CITY OF ALBUQUERQUE

November 5, 2024

RE: Mesa Del Sol Self Storage 5500 Turing Dr. SE Grading and Drainage Plan Engineer's Stamp Date: 10/30/2024 Hydrology File: R16DA1004

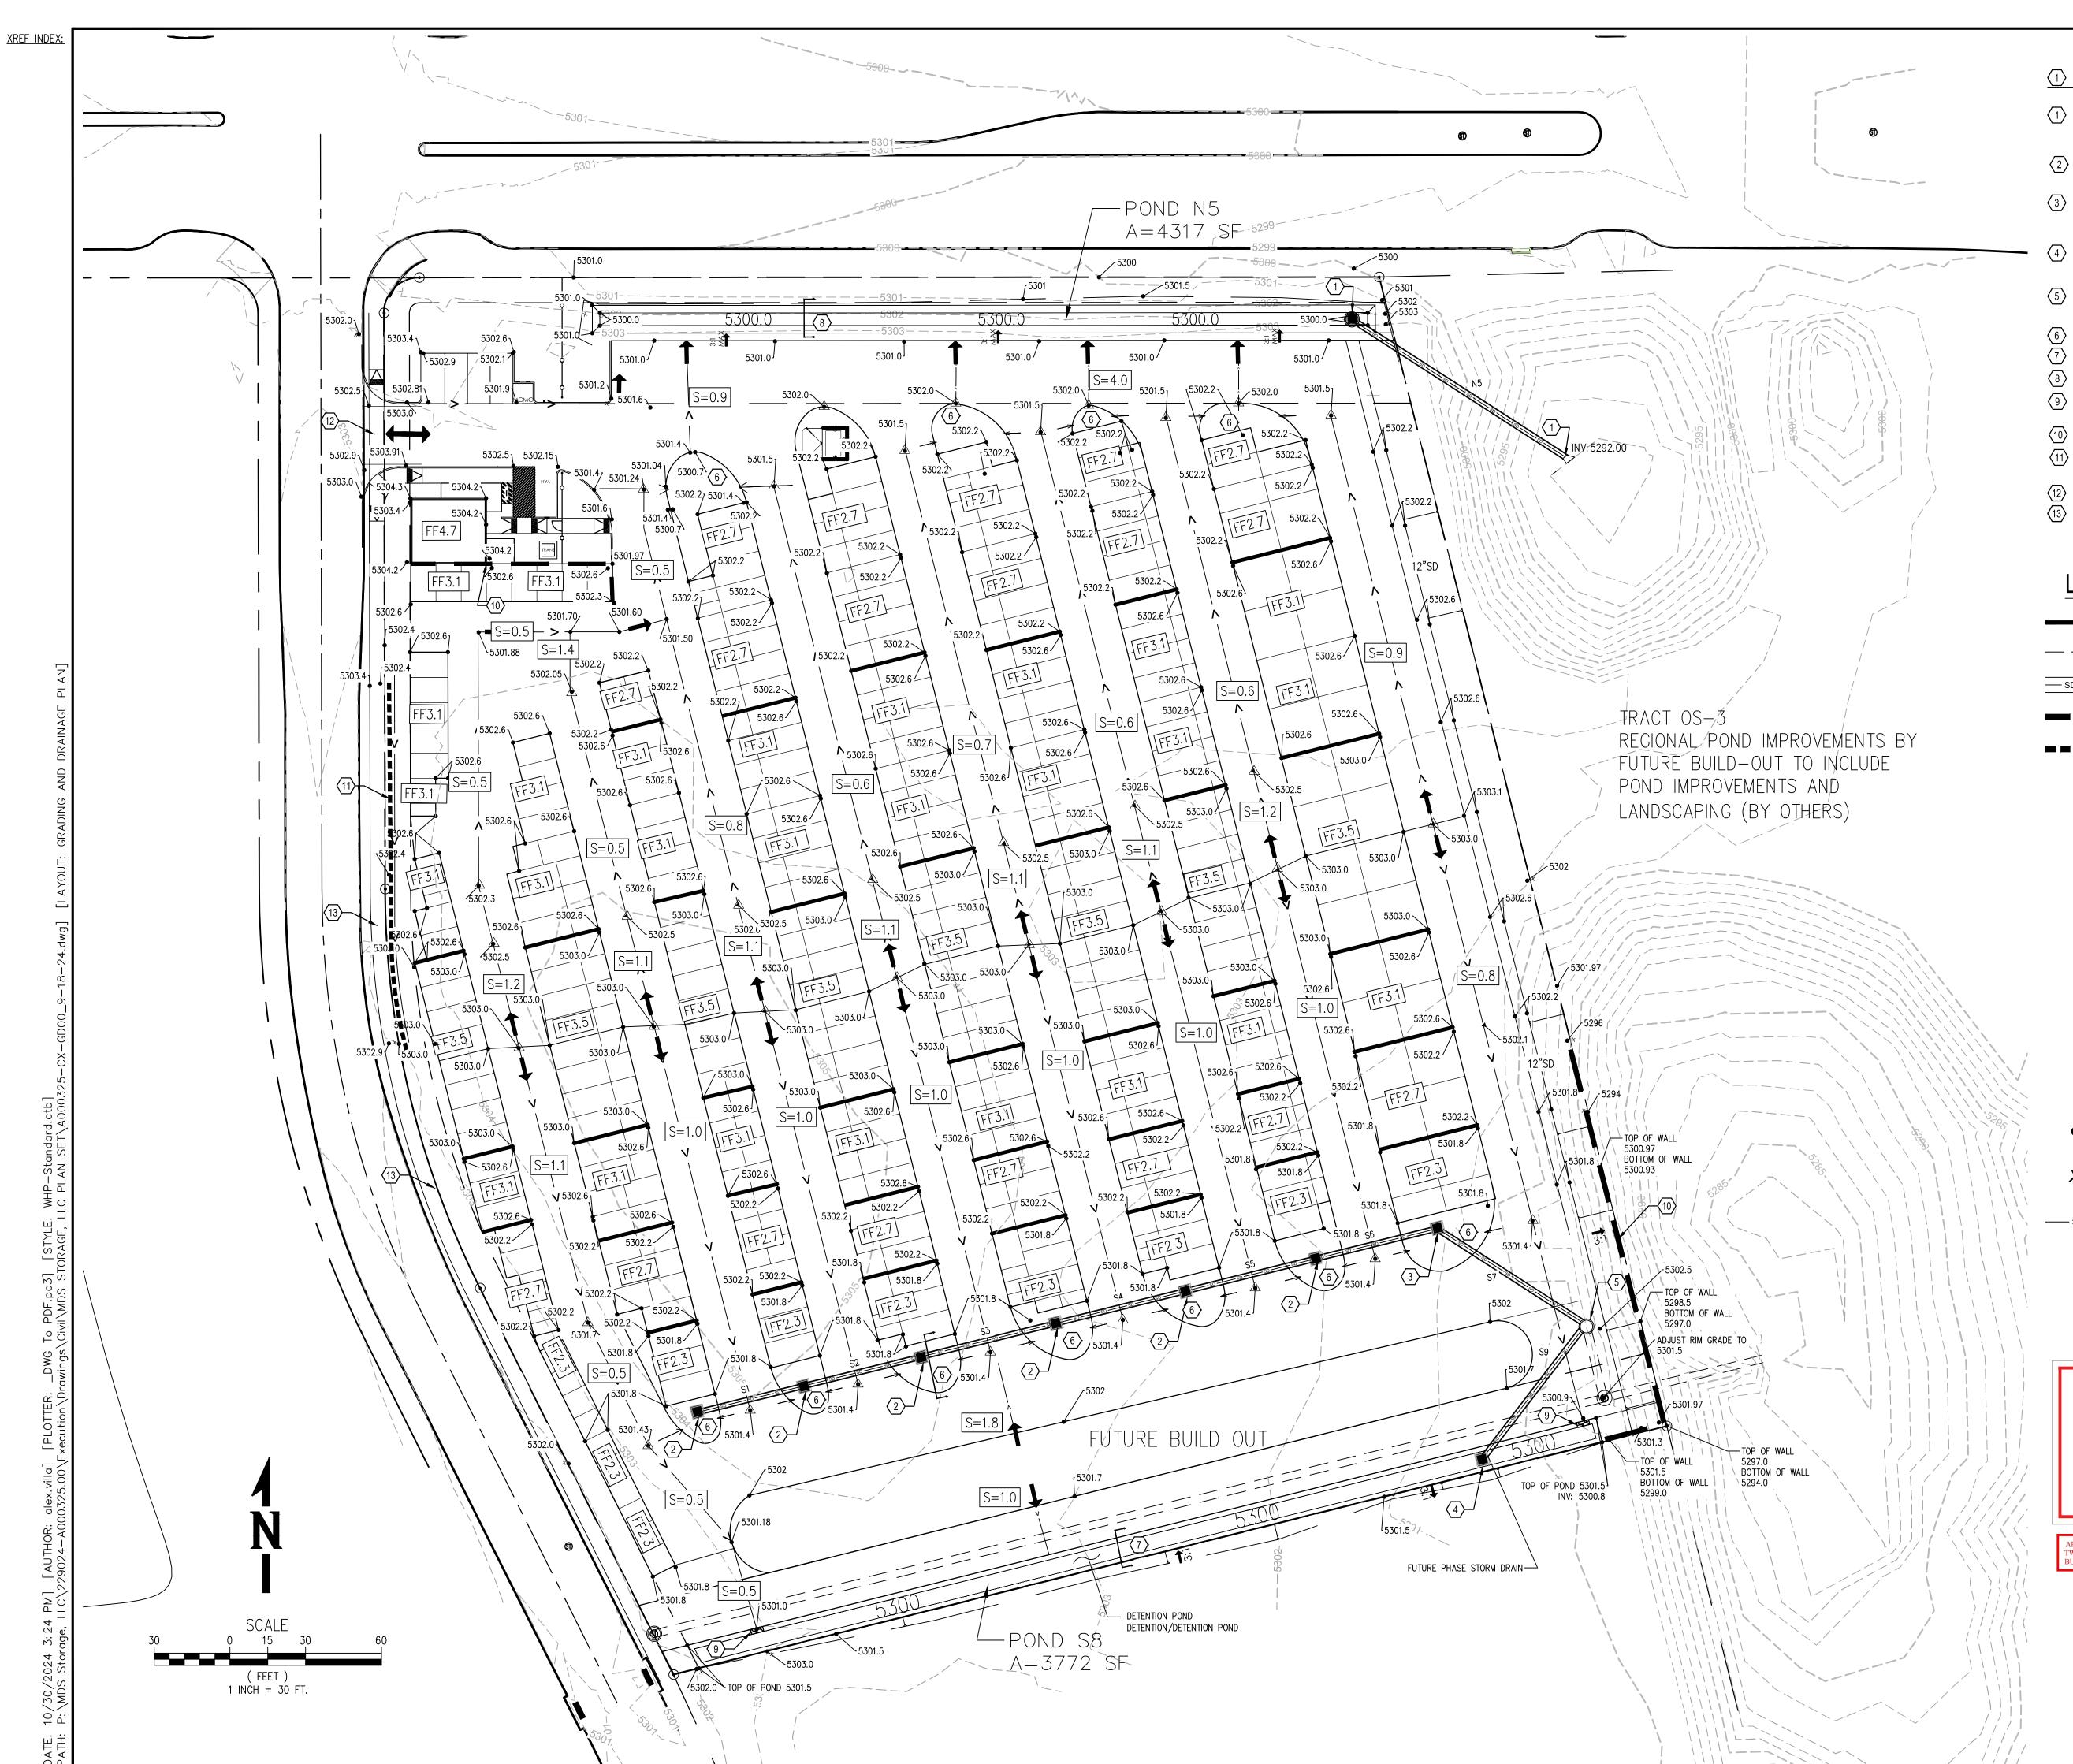
PO Box 1293	Based upon the information provided in your submittal received 11/01/2024, the Grading & Drainage Plan is approved for a Grading Permit . The following conditions need to be addressed prior to approval of a Building Permit.
Albuquerque	 Provide reference to Civil Detail Sheet C-2.0 for Keynote No. 8, Pond N5 Cross Section, Sheet C-501. Include erosion protection along pond alignment to maintain capacity. Provide reference to Civil Detail Sheet C-2.0 for Keynote No. 7, Pond S8 Cross Section, Sheet C-501. Include erosion protection along pond wall alignments to maintain capacity.
NM 87103	 Provide sections through all external boundaries showing proposed retaining walls, garden walls, property/ROW lines, existing and proposed grades. In accordance with DPM Ch.22, section 5, part B. Grading and wall construction near the property line may not endanger or encroach upon adjacent property or constrain its use.

www.cabq.gov	 Provide cross-sections for the proposed retaining walls at the southeastern area of project and the proposed garden wall at western area of project adjacent to the proposed sidewalk.

5. Please add a note in the cross sections, "Floodproof the retaining wall below the 100-year 10- day volume water surface elevation per the City's specifications."

6. Provide erosion protection at all locations of proposed improvements and particularly at outfalls into existing ponds.
	7. Confirm that the pipe invert elevation discharging into the northern pond will function with the record contours shown. Over time, rainfall events and sediment may have reduced the capacity of the existing ponds.

8. Provide current elevations at top and bottom of earthen ponds to demonstrate or confirm stormwater capacity of existing ponds to accommodate runoff into ponds per the stormwater Master Plan.

9. The existing ponds should be completely developed for the 100-year 10-day storm and associated capacity, together with slope erosion protection and access barricades where needed.

- 10. Per DMP, Part 6-11(D) Fencing Around Ponds: Fencing or similar barricade will prevent entry is required for private and public ponds where the water depth is 18 inches or greater unless side slopes are 3:1 (H:V) or flatter and the pond drains in 96 hours or less. Fence or barricade minimum height is to be 42 inches.
- 11. Please provide the Drainage Covenant with Exhibit A per Article 6-15(C) of the DPM. Please submit the original one-sided copies along with the \$25.00 recording fee check made payable to "Bernalillo County" to the Hydrology Section of Development Review Services on the Ground floor of Plaza de Sol.
